OAKLANDS FARM SOLAR PARK

Response by the Applicant on Landscape and Visual Matters

Document Ref: EN010122/D5/13.11

Image 1: OST5 Sample (with purple, red and green markers)

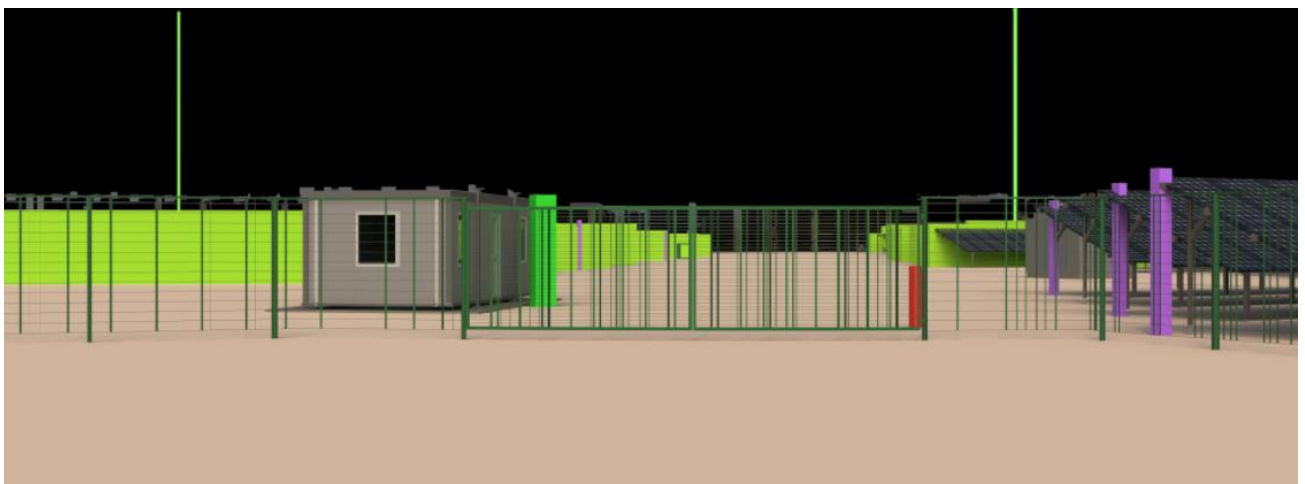
The visualisations have also been thoroughly tested by spot testing heights of all elements within the scene for the two viewpoints referred to by Ms Abbott (Viewpoints 1 and 2). This cross-check used 'markers' in a similar way to that undertaken by Ms Abbott (as set out in her response [REP1-043]), but with accurate measurements and positions, to confirm that new montaged elements are at the correct scale within the scene. For example, in Images 1 and 2 below, the purple markers shown alongside the PV panels on the right-hand side of the scene are confirmed as being 2.7m high.

Image 2: LiDAR 1m DTM

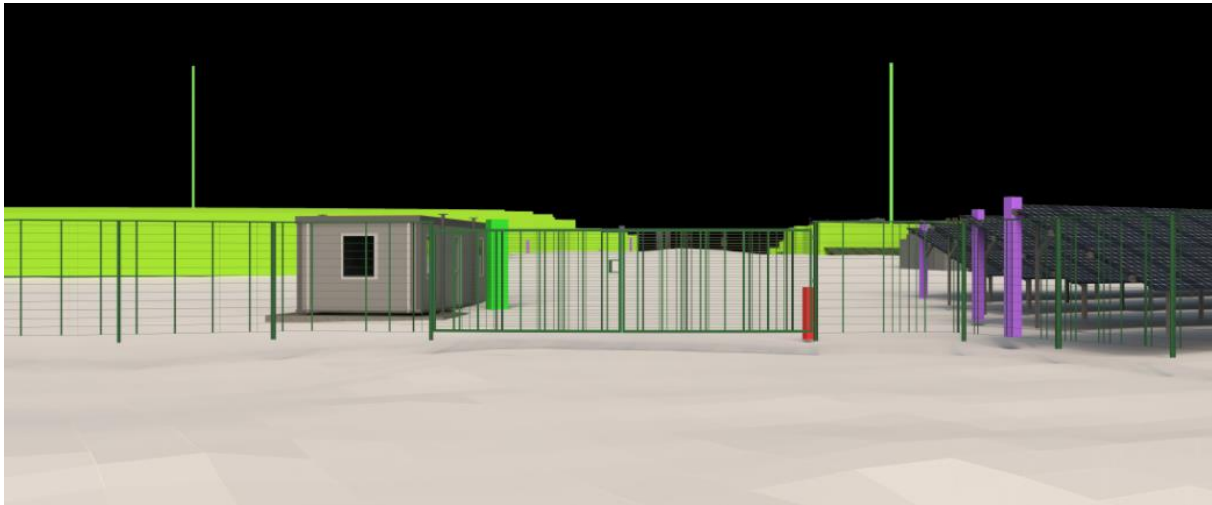
Visualisations were presented at the Issue Specific Hearing on 22nd October 2024 demonstrating any possible variance in height changes between OST5 and LIDAR terrain datasets with different coloured lines. Whilst noting that the original OST5 based visualisations are fit for purpose, and common place across the industry given this is the dataset that is typically used, the reduced RMSE for LIDAR could provide an increased level of accuracy at closer distances.

Image 4 – Comparative 3D environment used for rendering photomontage from Coton Road at the 'Twin Oak Tree' (looking roughly south) – demonstrating the green blocks at 2.2m high to cross check

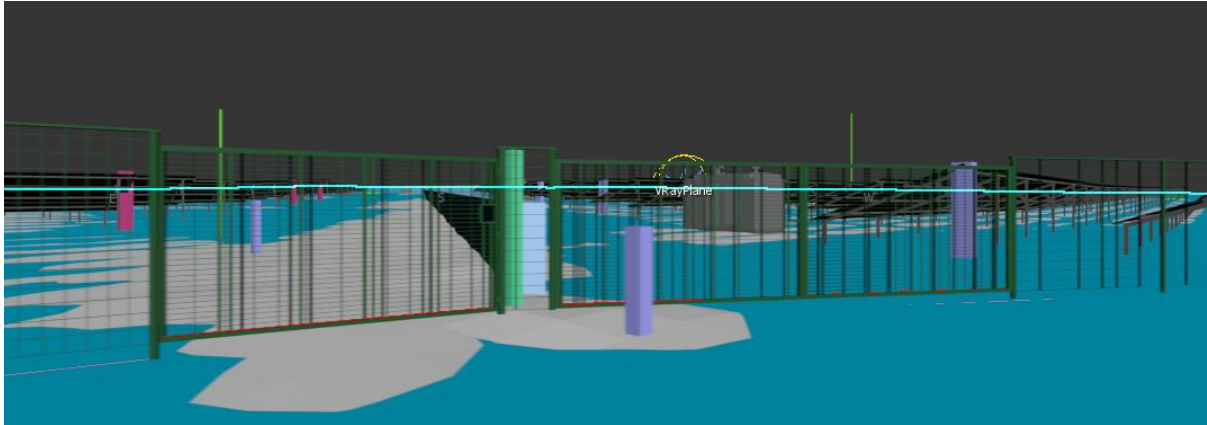
It is apparent that the cross check undertaken by Ms Abbott has not fully taken account of perspective, as the heights of existing elements (measured by Ms Abbott) are unlikely to be at the exact same distance from the camera as the element they are being used to gauge the scale of. Note for example the existing gate (measured below in **Image 3**) is significantly further forwards when compared to the actual position of the proposed security gate, as shown by the purple block in **Image 4**. The green block demonstrates a height of 2.2m within the scene.

heights, and the purple block at 1.1m in the position of the gate post measured in Image 3.
